**U.S. Department of the Interior**

Rock Springs District Office/Kemmerer Resource Area

June 1996

**FINAL**  
**Environmental Impact Statement**  
**Expanded Moxa Arch Area**  
**Natural Gas Development Project**  
**Sweetwater, Lincoln, and Uinta Counties, Wyoming**

Exhibit 2-1. Areas of High Potential for Encountering Paleontologic Remains within the Moxa Analysis Area.

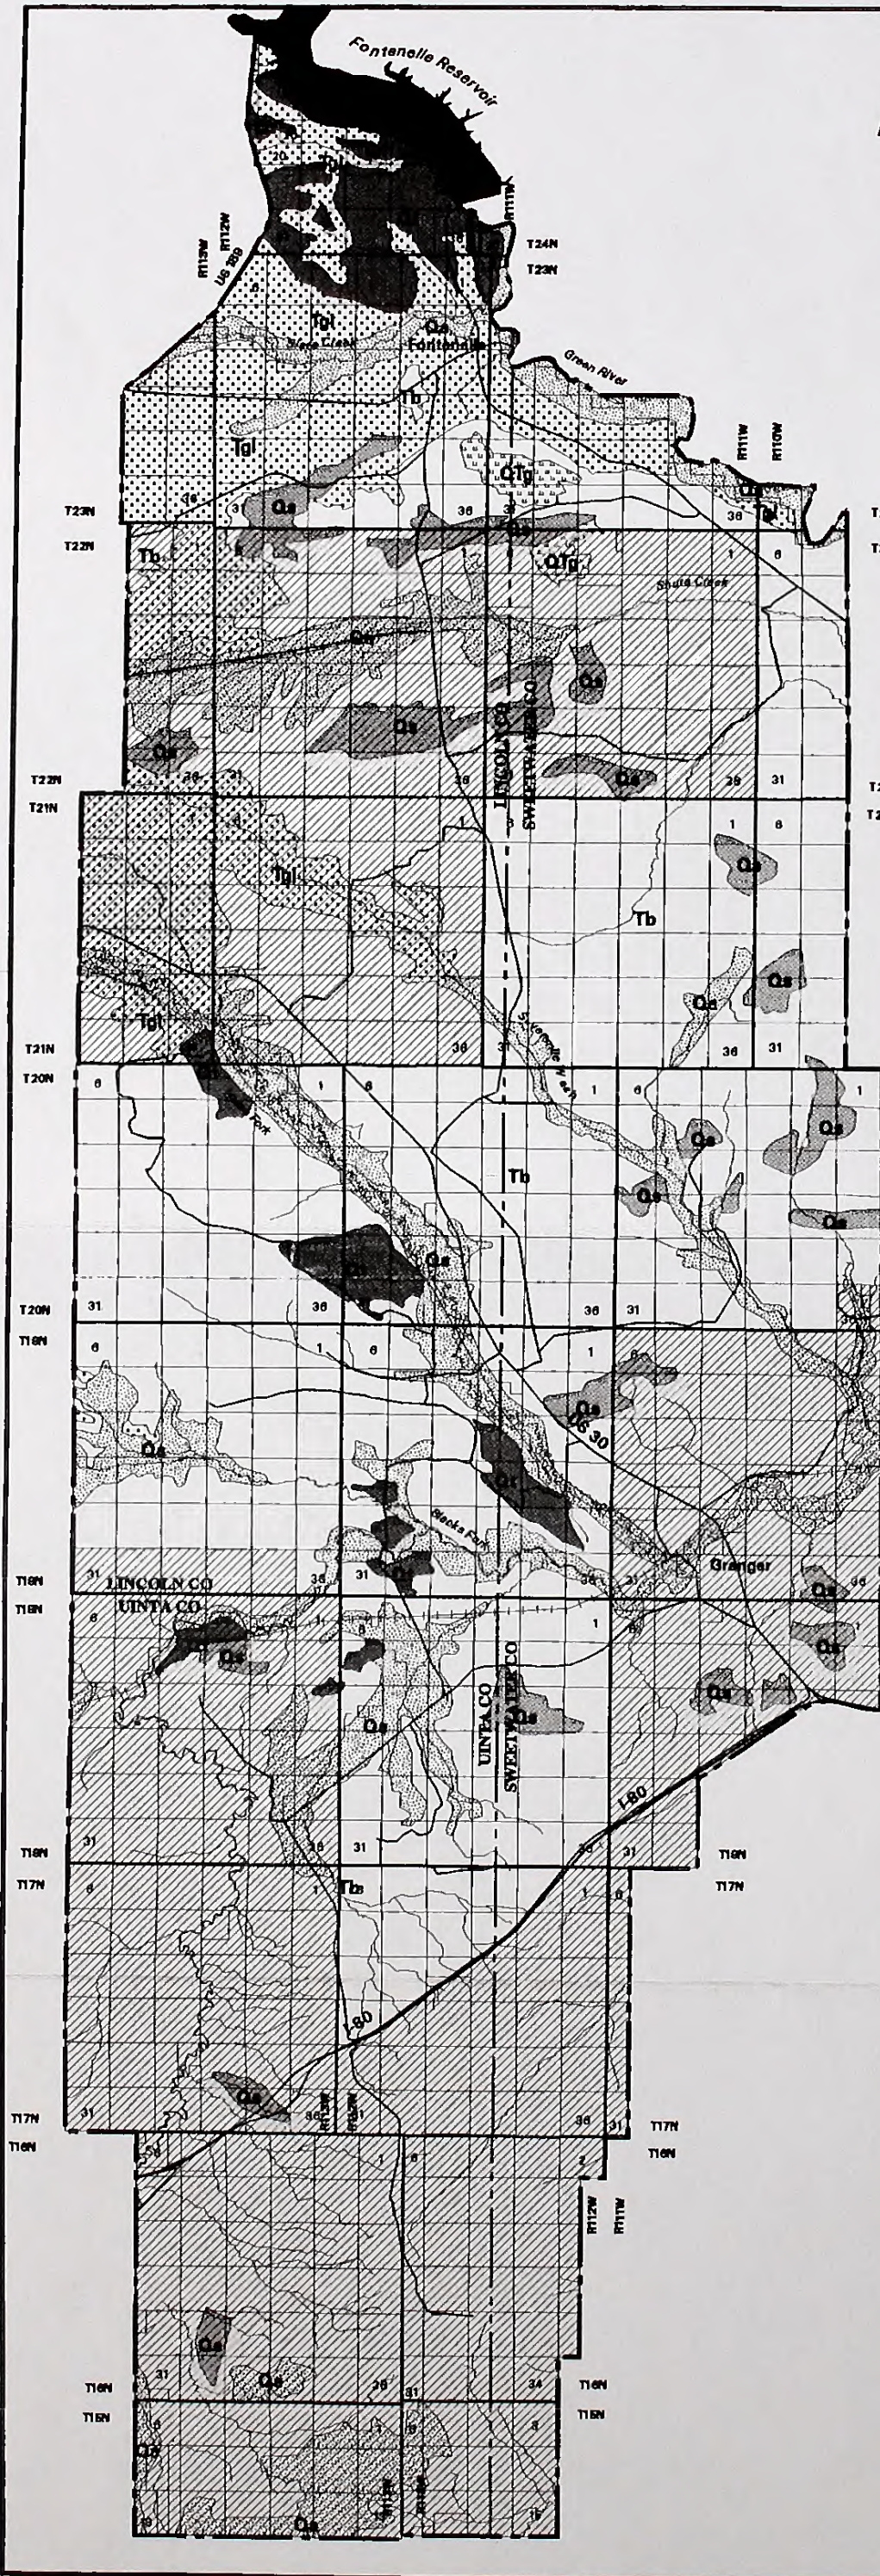
| Page                | Errata  |
|---------------------|---|
| 4-15                | <p><u>Paleontology</u>. Add under heading the following sentence: "The Kemmerer Resource Management Plan identifies the following requirements for the management of the paleontological resource:"</p> <p>Second bullet, add following corrections: "... Operations causing disturbance in areas of high paleontologic potential will require a paleontological survey by a qualified paleontologist as determined by the AO, and mitigating measures will ... known paleontological sites. See FEIS Exhibit 2-1 for areas of high paleontologic potential."</p>   |

Portions of the project area are considered to have high potential for paleontological resources, as depicted in the revised DEIS Exhibit 3-2 (See Section 2 Errata). Development proposals in those areas will be reviewed for their potential to impact paleontological resources. However, a paleontological survey will not be required in all cases. Factors such as the presence of surficial materials (i.e., alluvium, sand dune, gravel), the amount of bedrock to be affected, and results of previous surveys will be considerations in determining the need for a survey. The need for mitigation (e.g., monitoring construction) would depend upon the results of the initial survey and the recommendations of the BLM Resource Area Geologist. BLM intends to retain flexibility in its approach to requiring paleontological surveys.

| Page | Errata  |
|------|---|
| 3-12 | Section 3.4.3 Paleontology. Partial paragraph at top left, change second line to read: "... Green River Formation having paleontologic potential ..." Add to end of paragraph: "Information on the location of areas of high paleontologic potential are shown on FEIS Exhibit 2-1." Exhibit 2-1 is a new addition to the DEIS and is found at the end of the Errata section in this FEIS.  |

Exhibit 2-2. Sensitive Resource Areas Within the Moxa Analysis Area Subject to Drilling Restrictions.

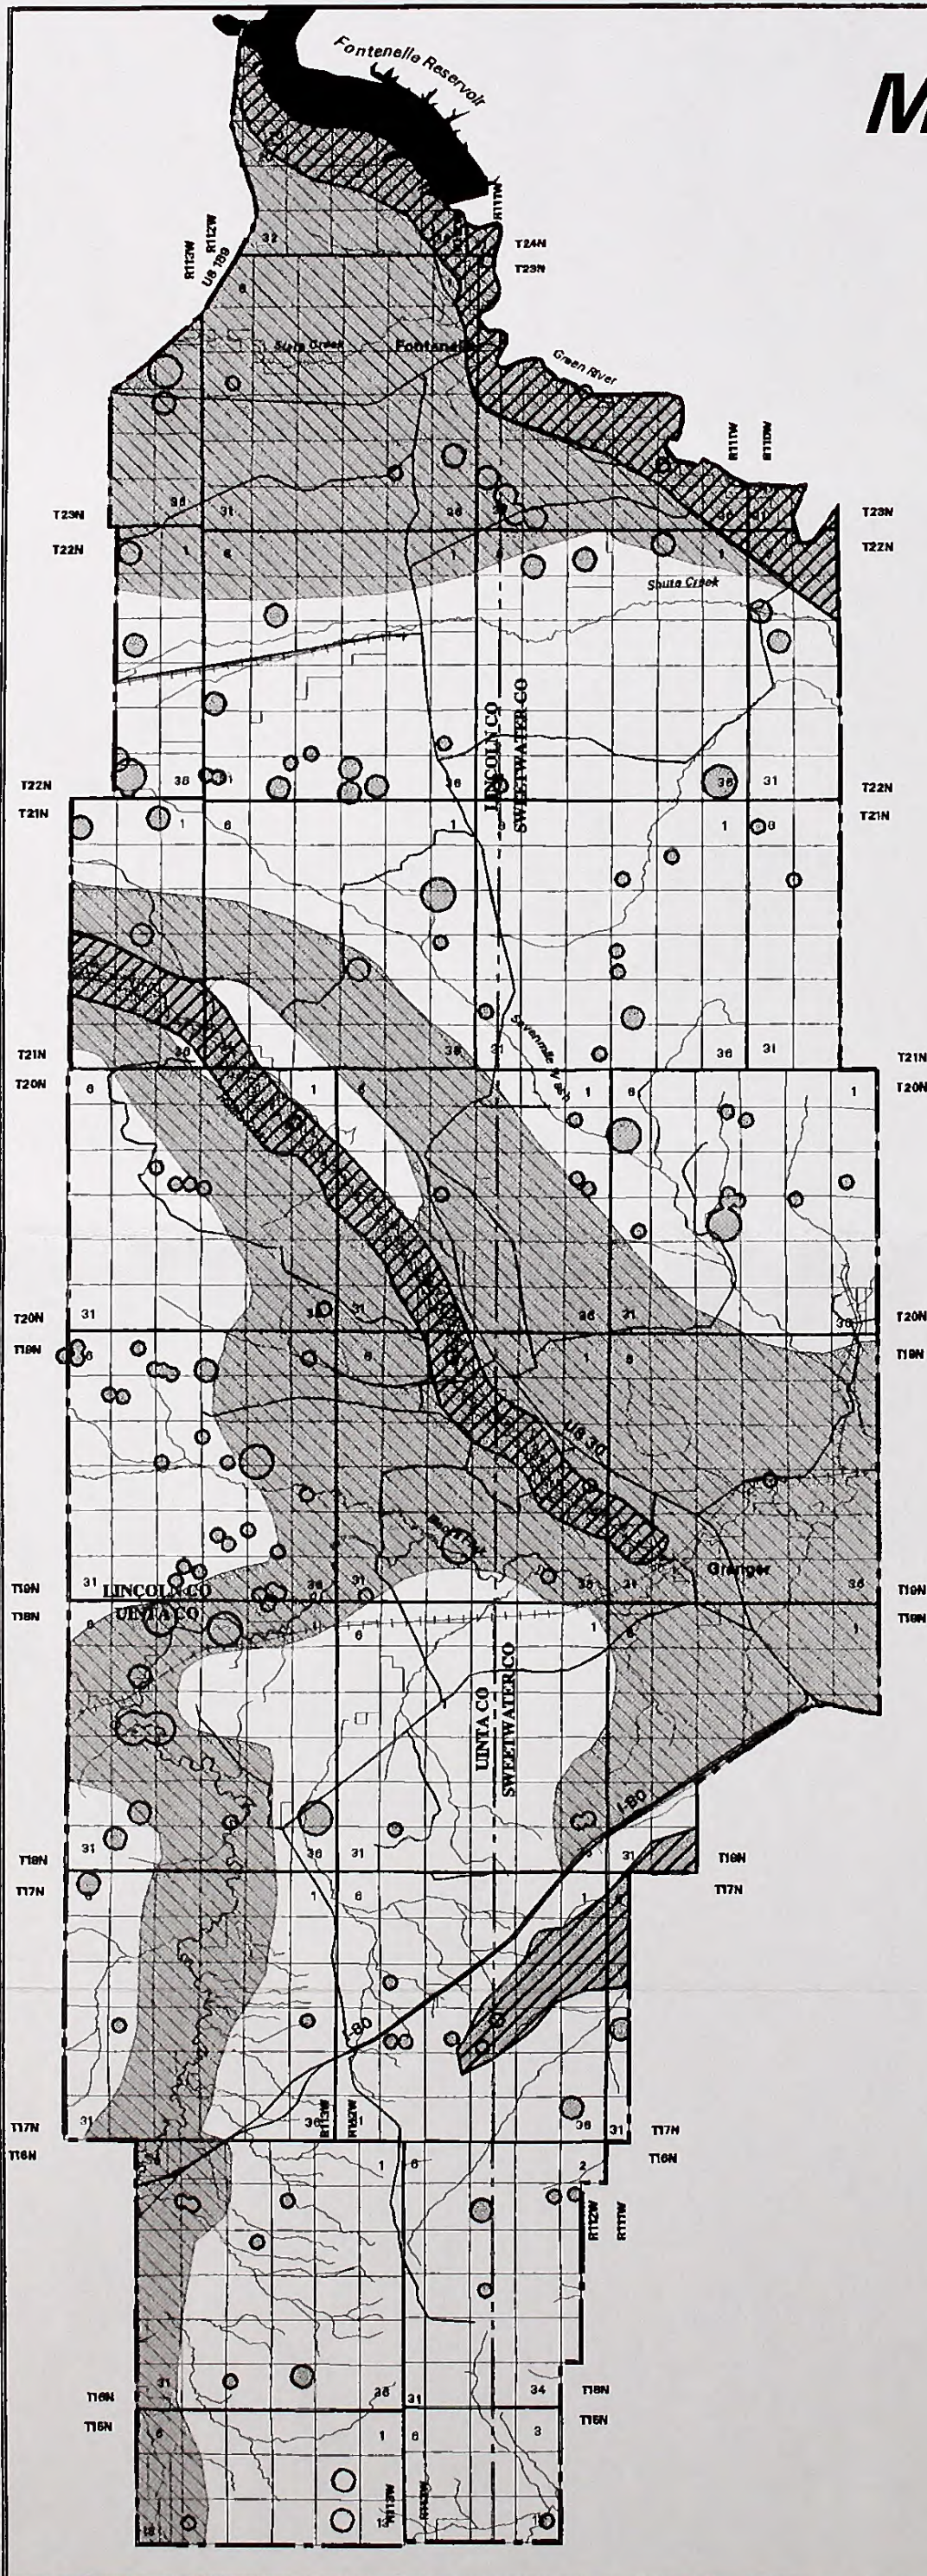
As stated in the DEIS (page 2-8), "Some surface locations within the Moxa analysis area may not be feasible to construct and occupy for economic...physical...or other environmental reasons (e.g., areas of crucial winter range). Where economically feasible, the Moxa Operators may use directional drilling from a single-well pad...to access bottom-hole locations in these areas. Generally, BLM would require consideration of using an existing well pad to directionally drill additional wells in sections where site occupancy limitations exist." Exhibit 2-2 has been added to show the approximate location of where the site occupancy limitation areas or sensitive areas are within the Moxa Arch project area subject to directional drilling consideration. See Section 2 Errata.
